Department of Public Works

Agenda for April 23, 2019

CAMDEN COUNTY PLANNING BOARD
Land Development Review

**CAMDEN COUNTY PLANNING BOARD
COUNTY ENGINEER'S REVIEW
OF SUBDIVISIONS AND
SITE DEVELOPMENT PLANS**

STAFF REPORT MEETING OF:	RE:	101 Haddon
	Plan:	8/1/2019
	Municipality:	City of Camden
	Applicant:	Camden County Improvement Authority
	Abuts County Route:	Cr. 561 Haddon Ave.

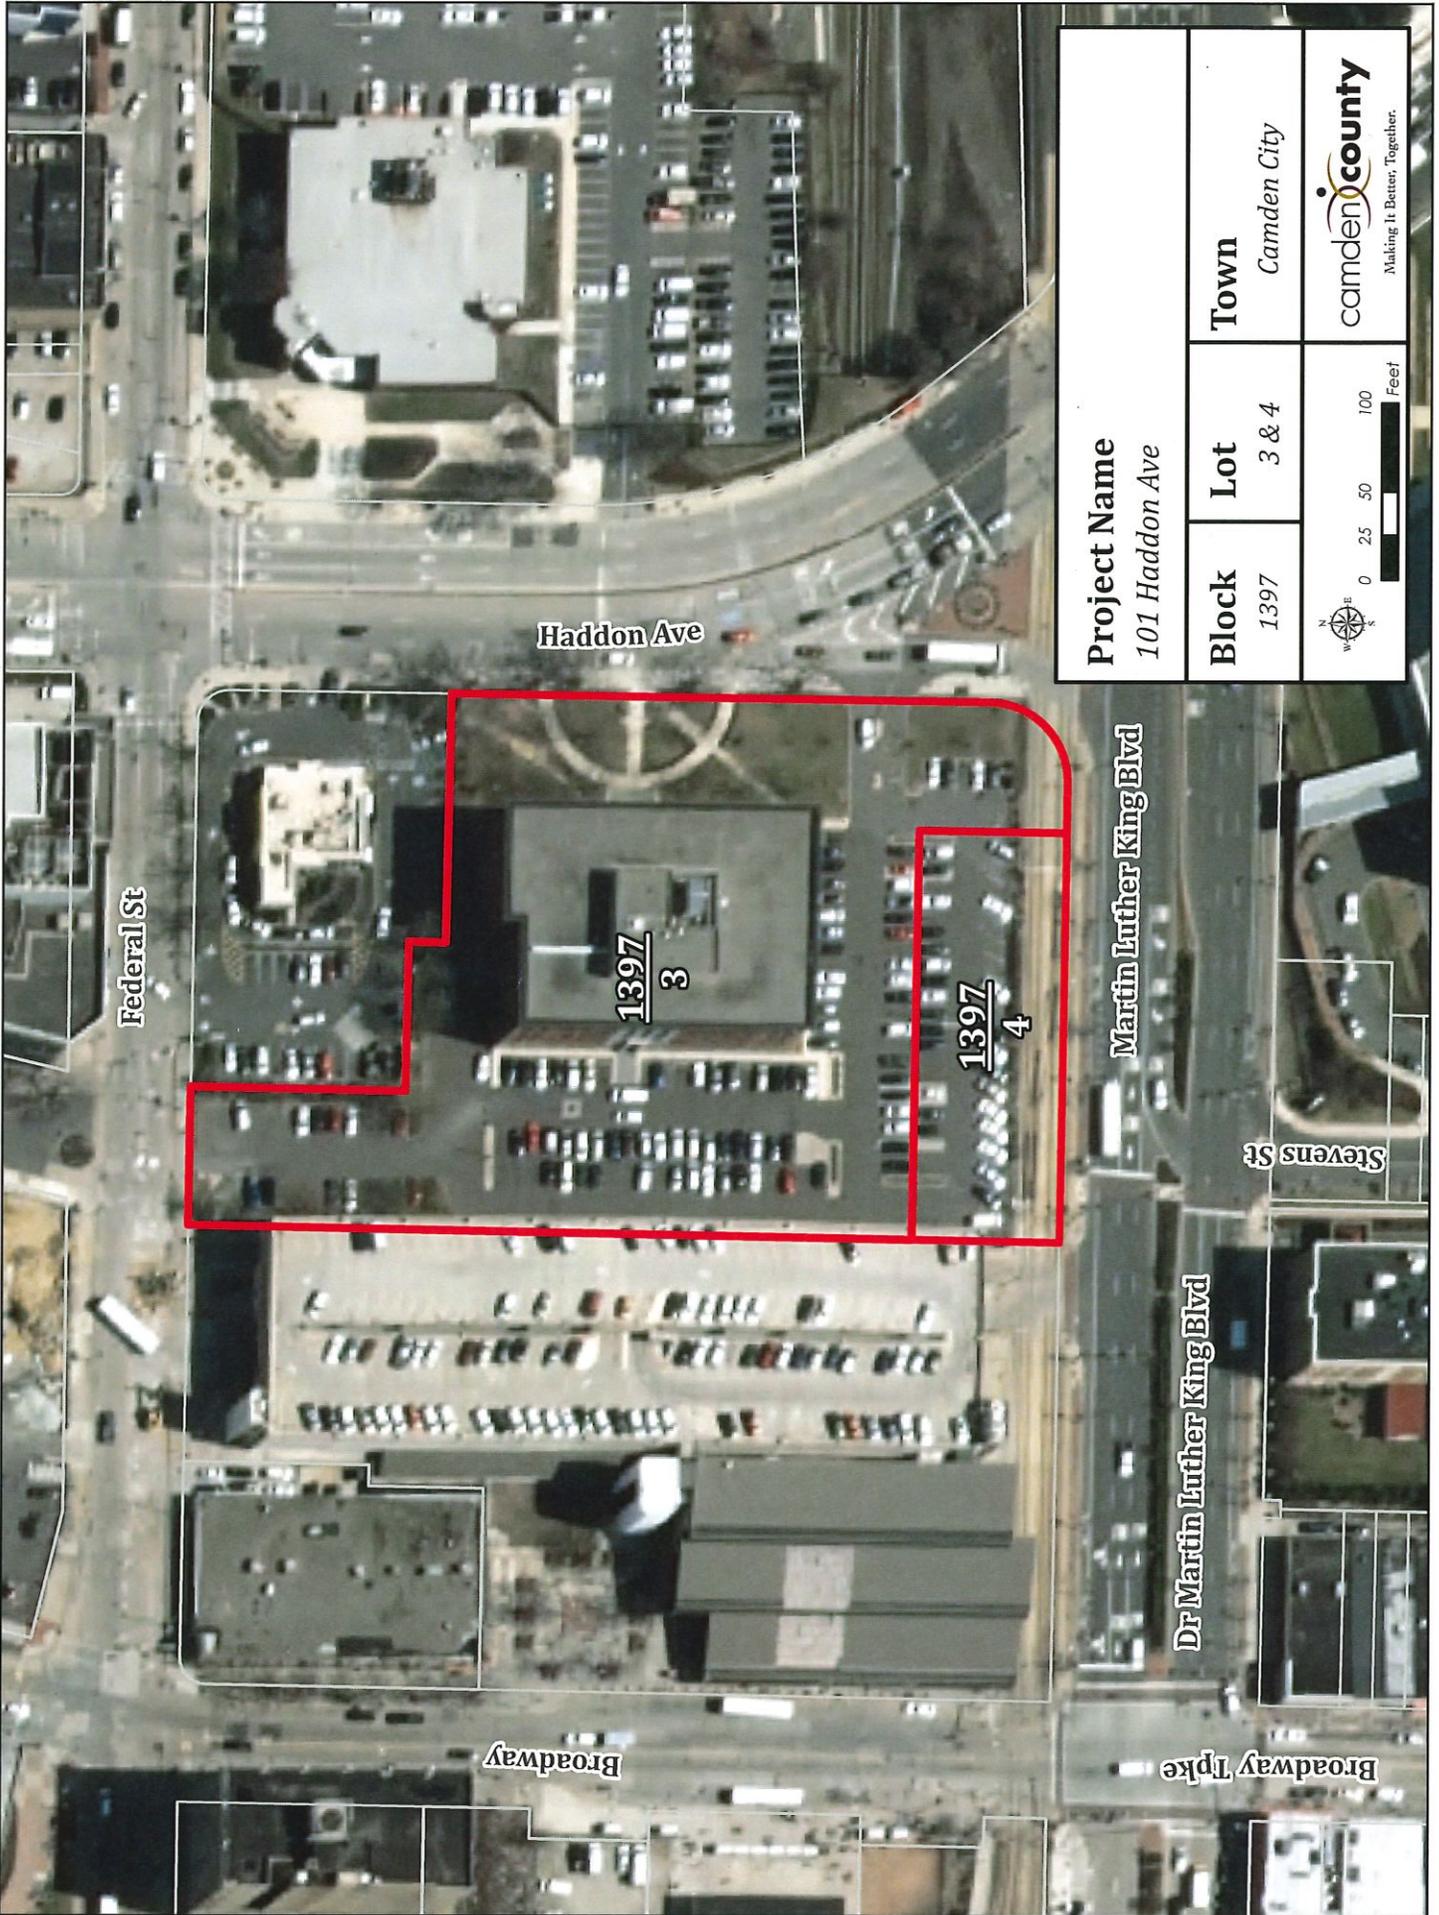
1. The Camden County Master Plan indicates that Cr. 561 Haddon Ave. and Cr. 537 Federal St both have proposed right-of-was of 66 feet and both have an existing right-of-way of 66 feet. The applicant is not required to provide additional right-of-way.

1. The plans should include a note indicating "All sidewalk and curb within the County right-of-way along the property frontage that is deteriorated or presents a tripping hazard shall be replaced under the direction of the County Engineer or his/her representative.
2. The site plan should include stop signs and stop bars at each driveway entering the County Road.
3. Site Plans Must Conform with the Following Standards:

3.3.1 Access Location, Access Spacing, Access Restrictions, and Intersection Design
Applicant is proposing to change the access along Haddon Ave. from a two-right-in right-out driveway to a one-way right-in only driveway

3.3.1.10. E Driveway and Apron Material
Applicant proposed to replace the driveway apron along Federal St. driveway.

C-1.0
SITE IMPROVEMENT
PLAN
(OVERALL)

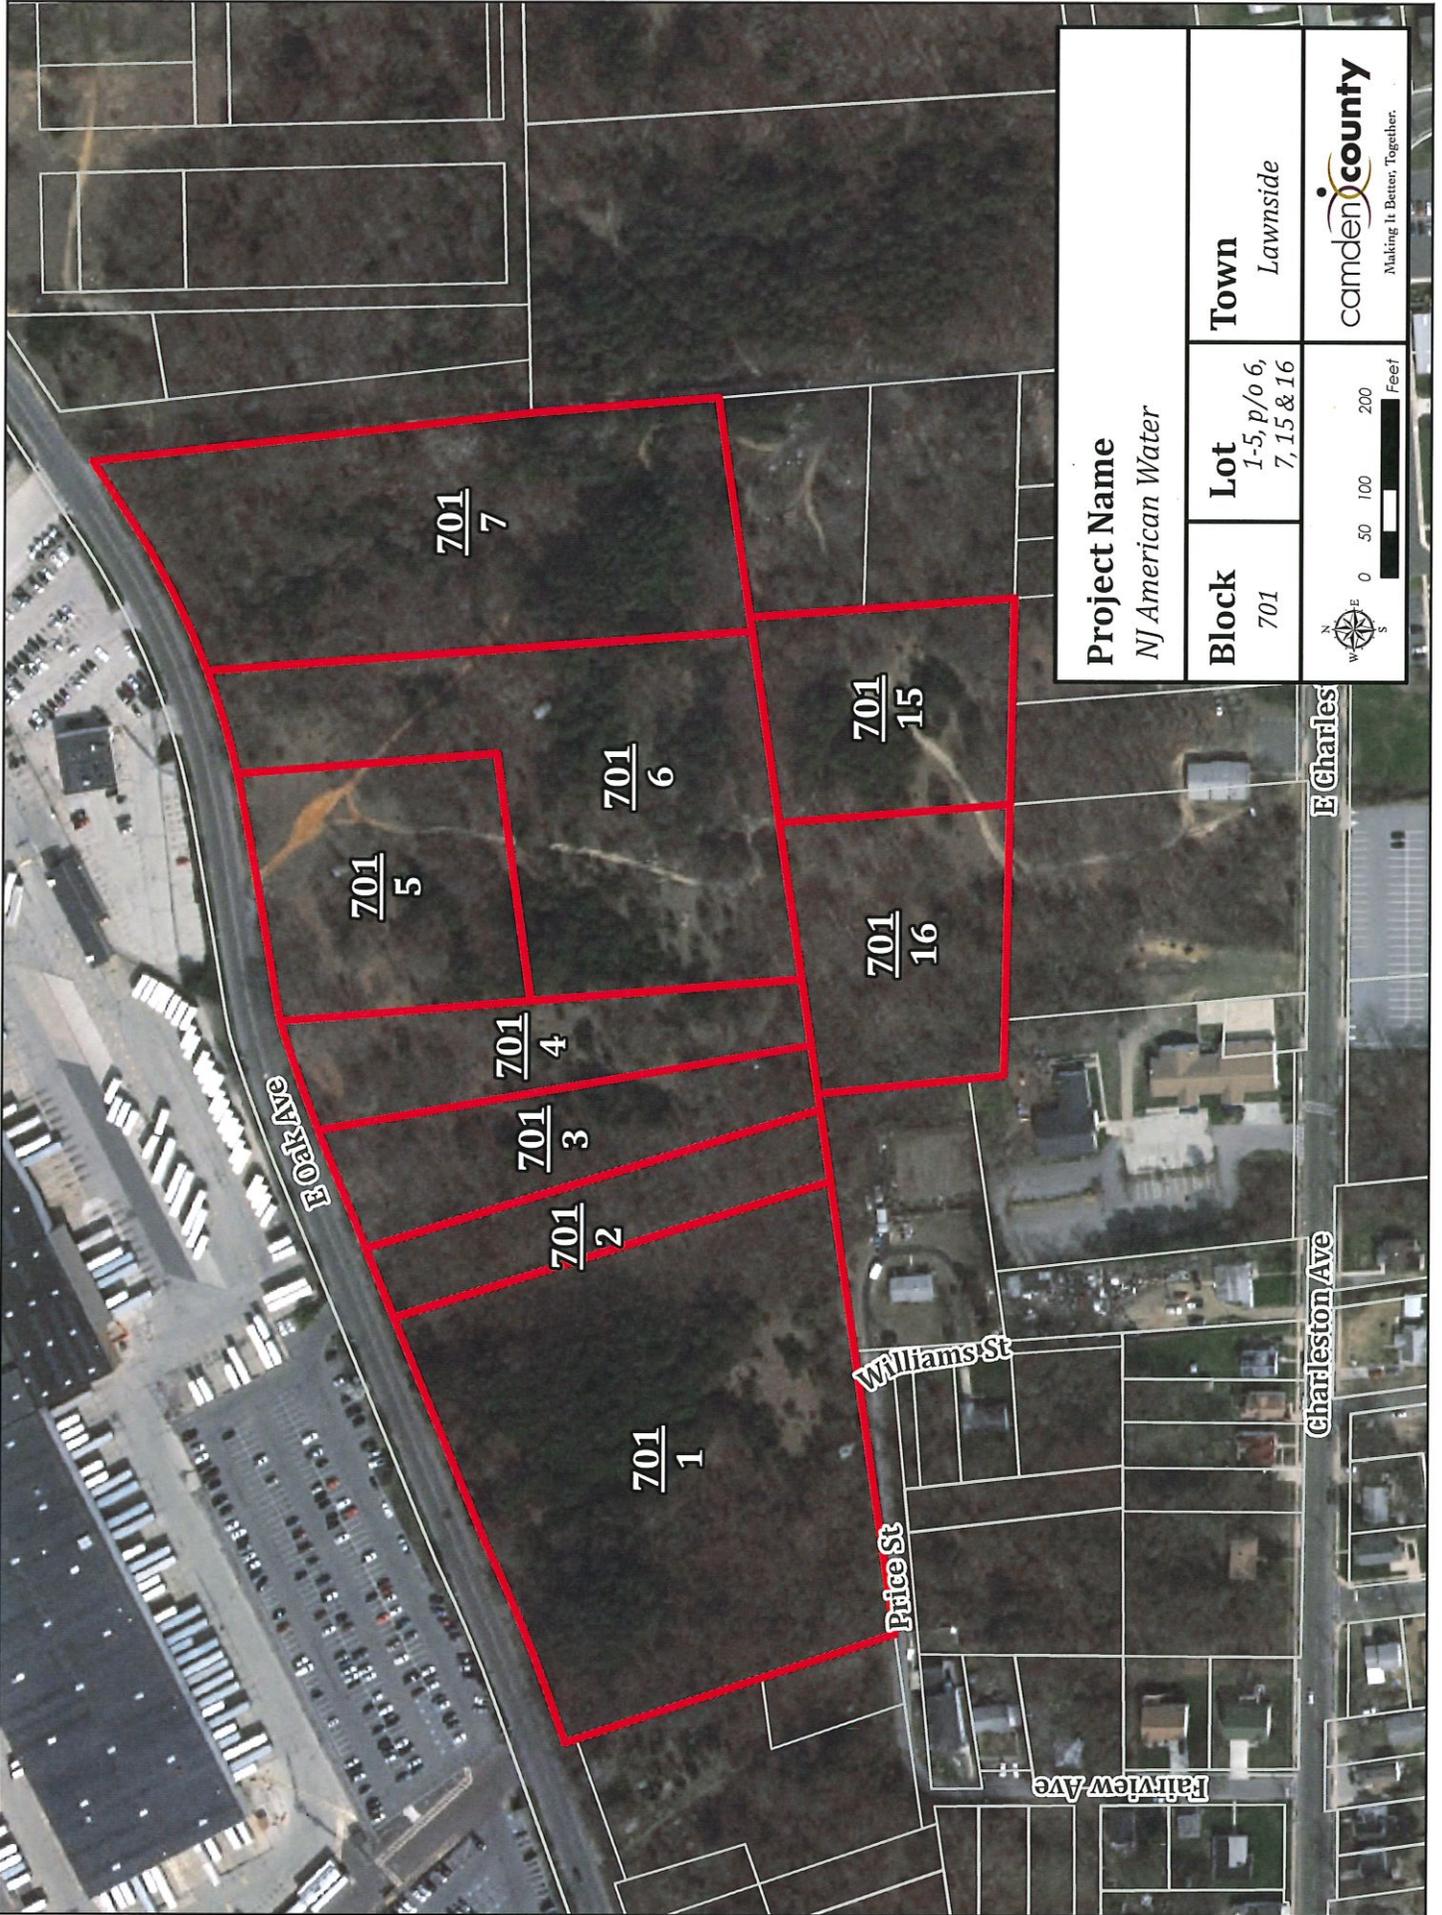
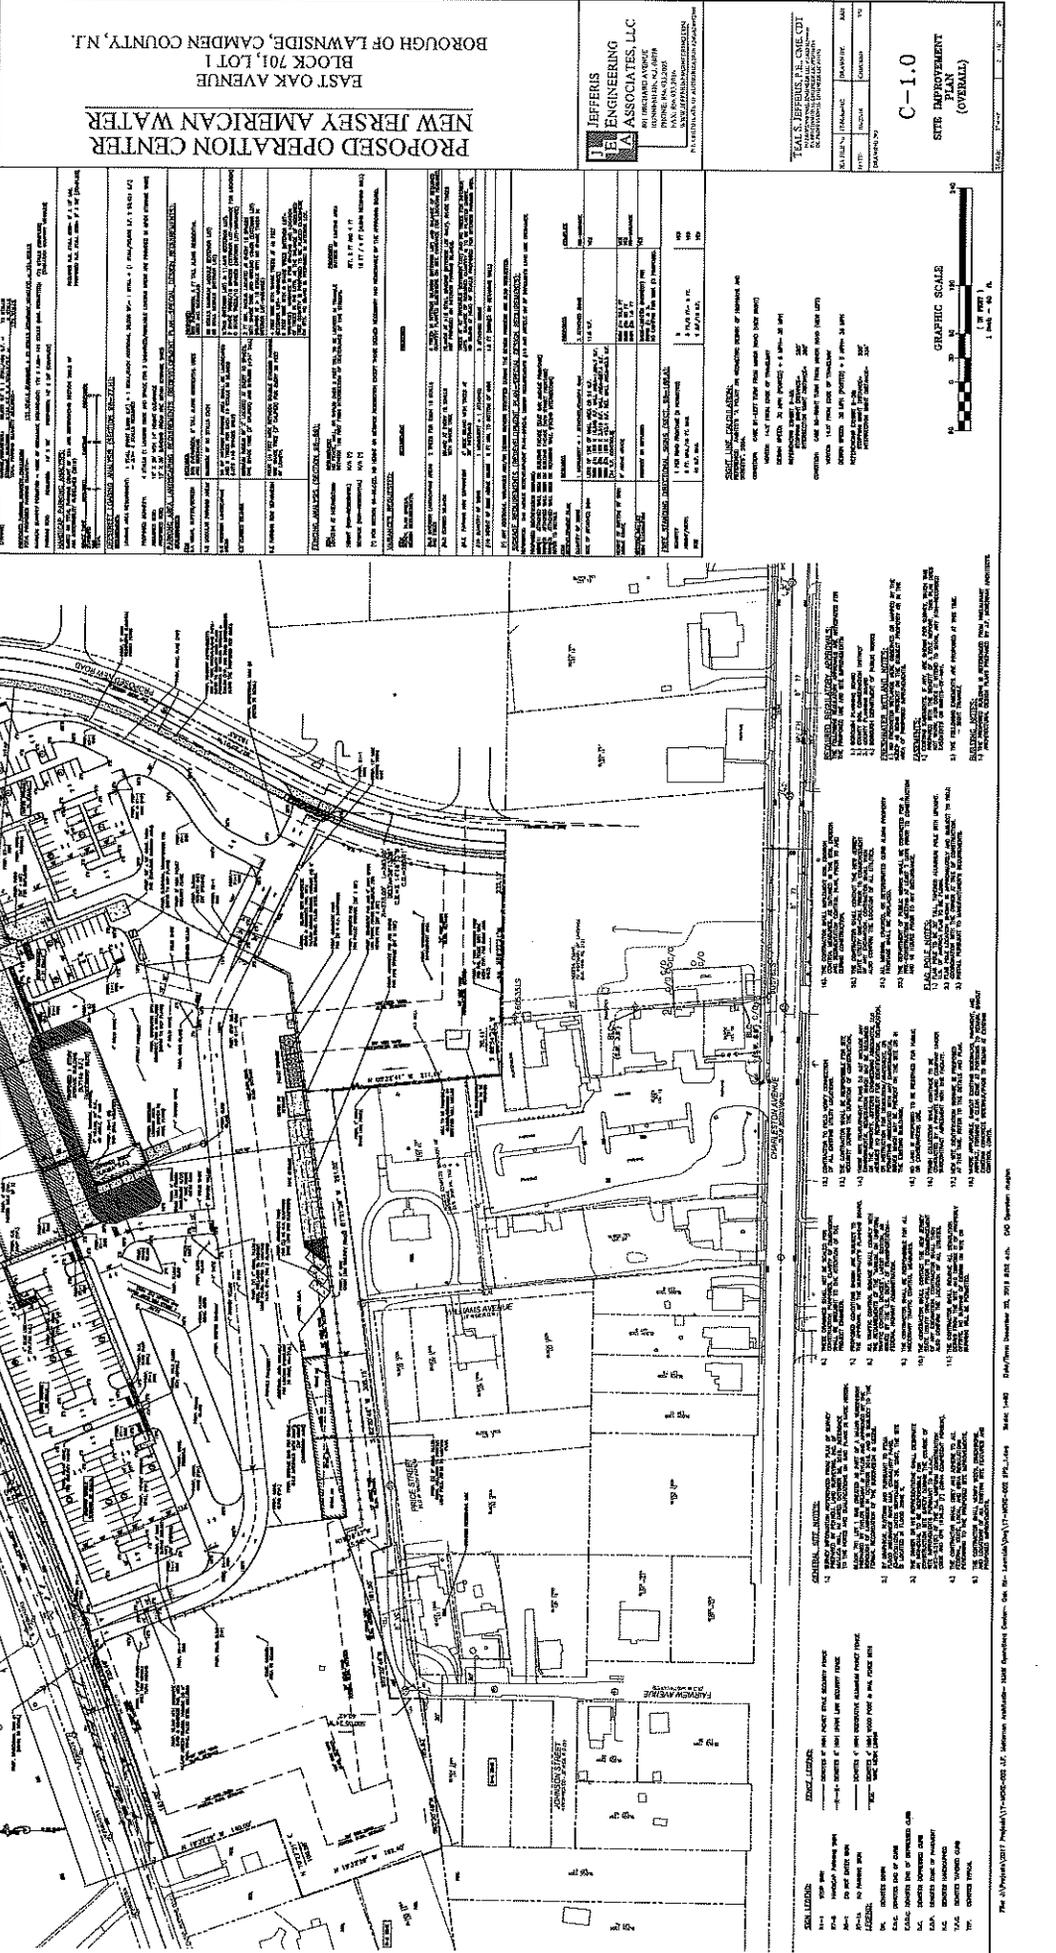
1. East Oak Avenue (C.R. 667) has a variable existing right-of-way, measuring sixty feet (60') at the location of this development. The applicant is required to provide additional right-of-way through a dedication to Camden County to widen East Oak Avenue from the centerline forty feet (40') along the applicant's frontage to the intersection with the proposed new road.

- a. The site plan should be revised to indicate the right-of-way dedication to Camden County.
 - b. The right-of-way dedication should extend from the existing right-of-way to the proposed right-of-way, which is measured forty feet (40') from the roadway centerline.

5. All storm inlets and structures within the County right-of-way should be numbered and labeled on the roadway plans and profiles (Sheets 2-4) and on the roadway cross section (Sheets 3-8). Proposed sanitary sewer and water laterals should also be provided on the plans.

6. Additional roadway cross sections at the locations of the proposed storm sewer structures should be added to the Roadway Improvement Plans. The location of these storm sewer structures must be coordinated between the Roadway Improvement Plans and the Site Plans.

10. An ADA ramp detail with truncated domes should be added to the Roadway Improvement Plans.
11. A north arrow should be added to Sheet 4 of 9.

1. The applicant is proposing one (1) driveway with full movement in and out onto East Oak Avenue (C.R. 667).
2. The centerline of the proposed driveway is approximately twelve hundred forty (1240') west of the centerline of the intersection of East Oak Avenue (C.R. 667) with the Proposed New Road.
3. The plans should be revised to provide a concrete driveway apron for a distance of twenty-five feet (25') from the edge of the proposed roadway pavement in accordance with Section 3.3.1.10.E.

3. The length, size, material and slope of any proposed storm sewer pipe shown on the Grading & Drainage Plan must be provided. The storm sewer structures must also be identified.

7. The plan should include details for Type N eco grates for the storm inlets in the County road.

STAFF REPORT MEETING OF:	RE:	Pilgrim Woods
	Plan:	MJ-36-2-19
	Municipality:	Winslow Twp.
	Applicant:	Glouco Approvals Group, LLC
	Abuts County Route:	Cr. 720 Blue Anchor Rd.

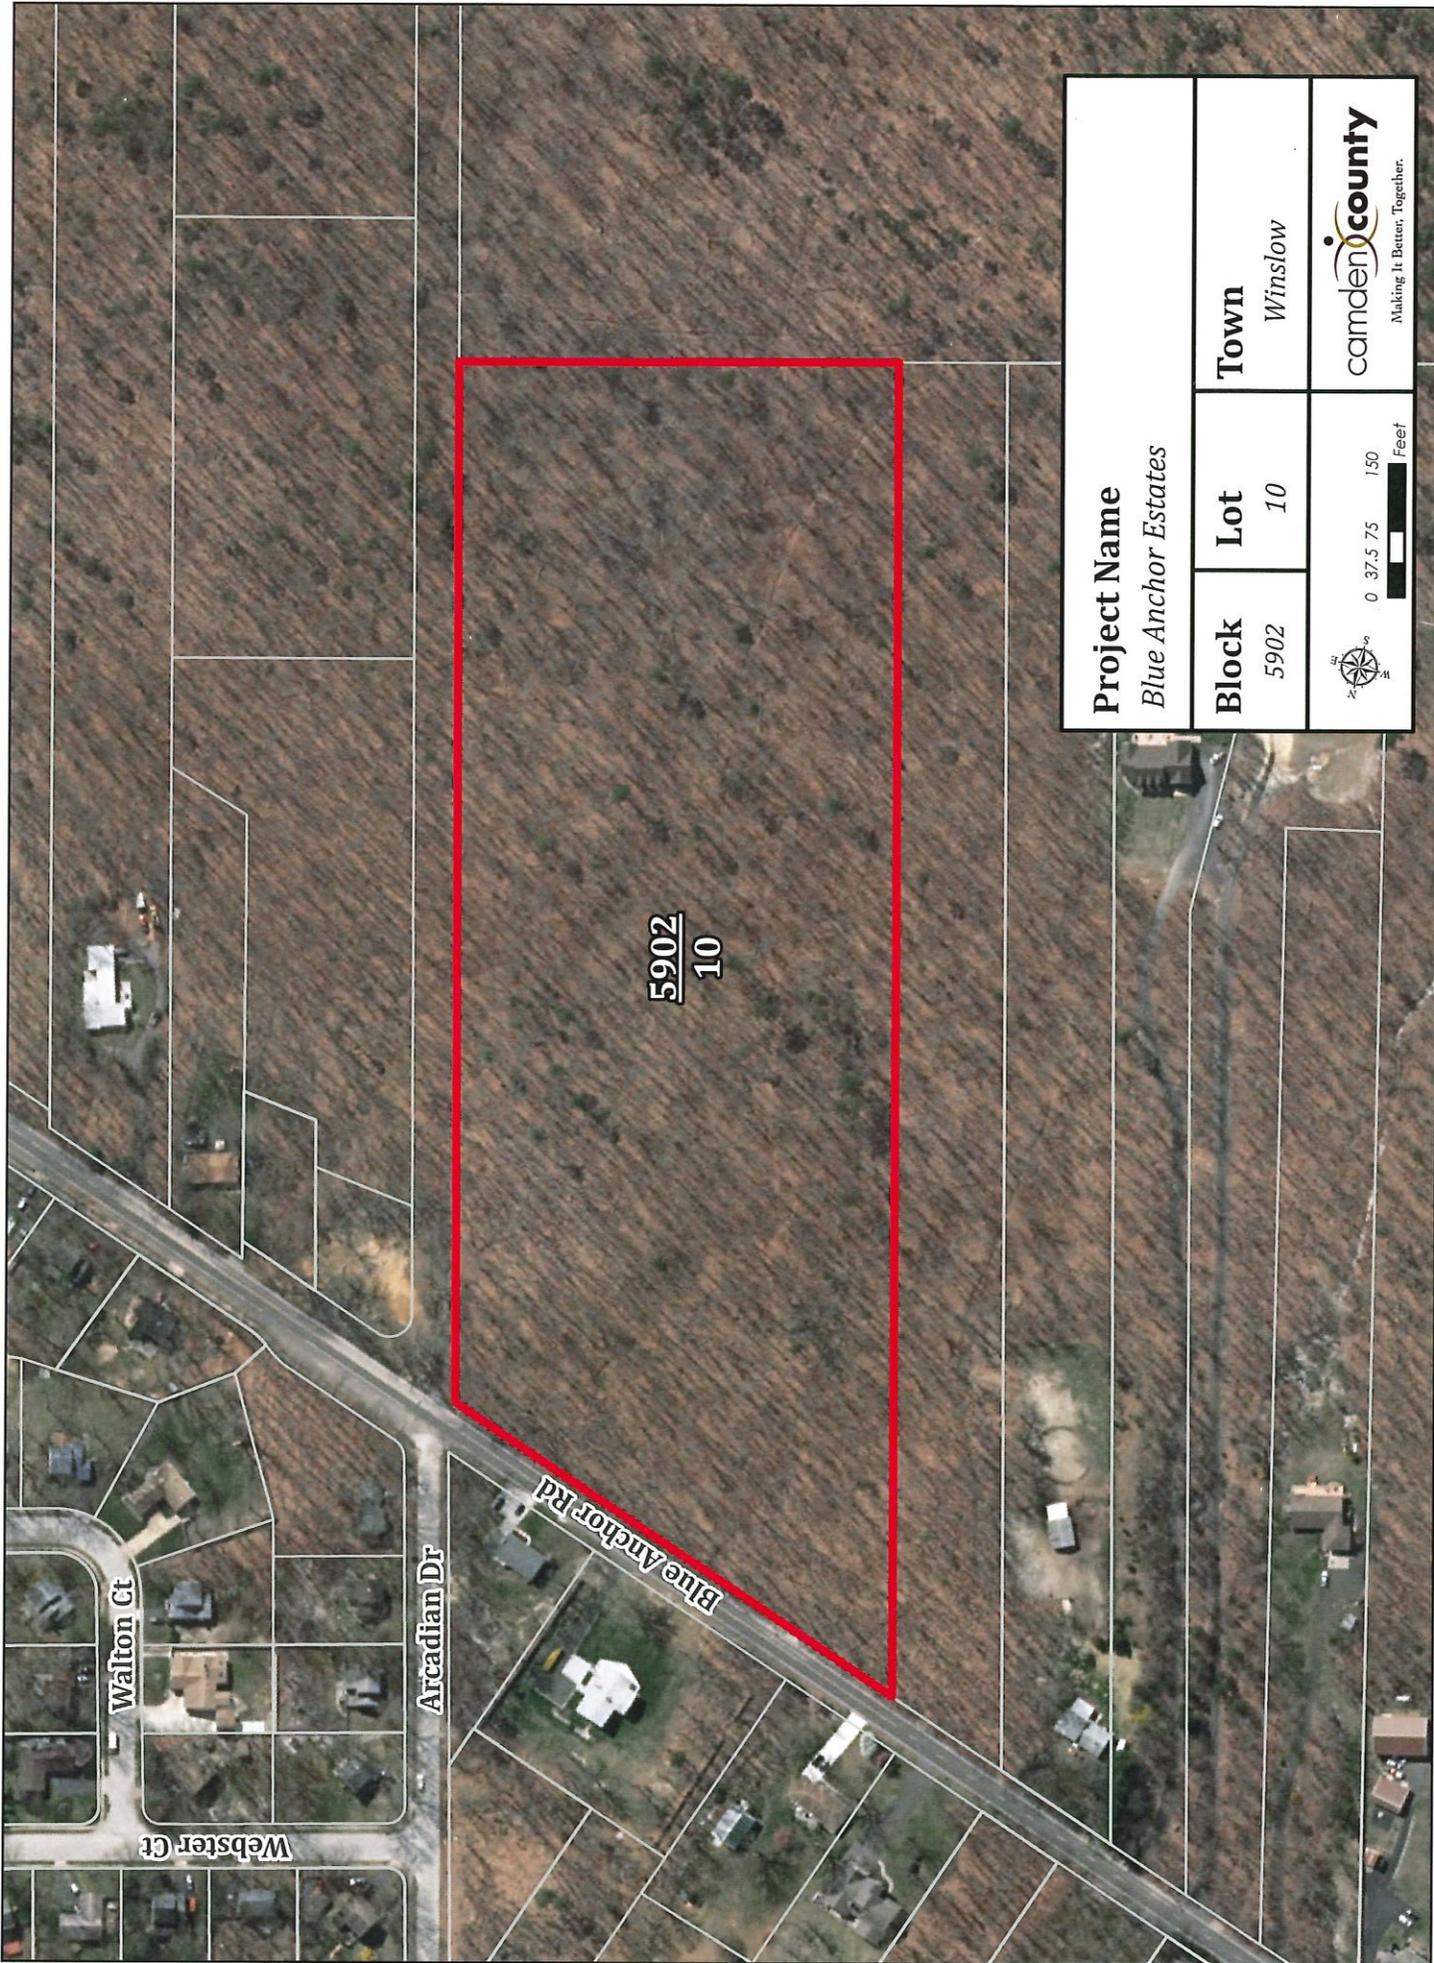
1. The Roadway Improvement Plan, Sheet 11 of 13, dimensions a 75-foot long and 9-foot wide acceleration and deceleration lane. Applicant has designed the requested acceleration and deceleration lanes per County Standard Detail No. 22, Bypass Area.
2. Applicant shall revise design to provide the Minimum 12-foot lane width per County Standard Acceleration and Deceleration Lanes Detail No. 13; or receive concurrence from the County the bypass area design is adequate to support proposed traffic operations at the site access.
3. Applicant shall dimension proposed lane widths and shoulder widths.
4. Applicant shall detail proposed signing and striping at the site access on Sheet 4 of 13, Site Plan Layout per the applicable County Standard Details.
5. Applicant shall include Standard Pavement Marking Legend, County Standard Detail No. 10, as part of the revised plans.
